TOWN OF ARLINGTON
 Public Works Standard Details

RESIDENTIAL DRIVEWAY
 TYPICAL SECTION

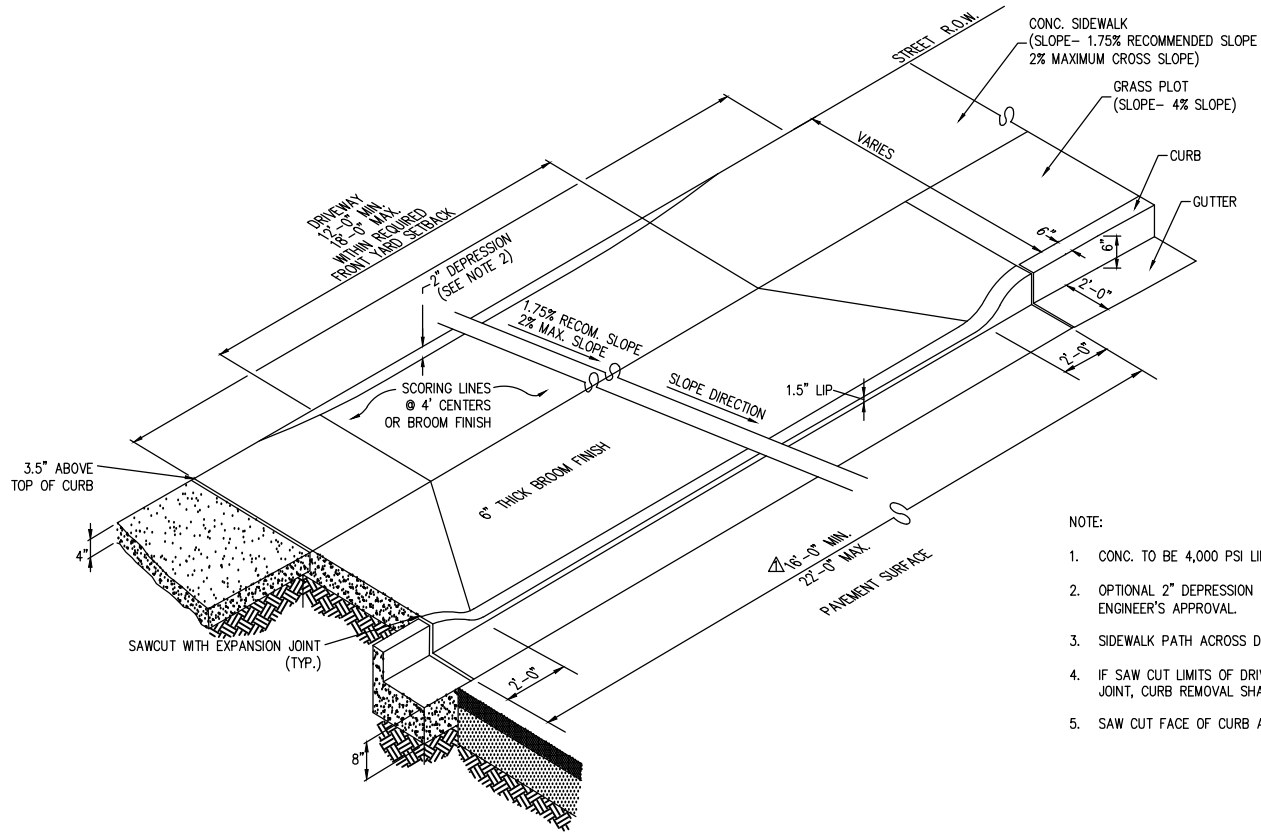
REV. 1: REDUCED MINIMUM DRIVEWAY OPENING
 AT STREET FROM 20' MIN. TO 16' MIN.
 REV. 2: ADDED NOTE 5
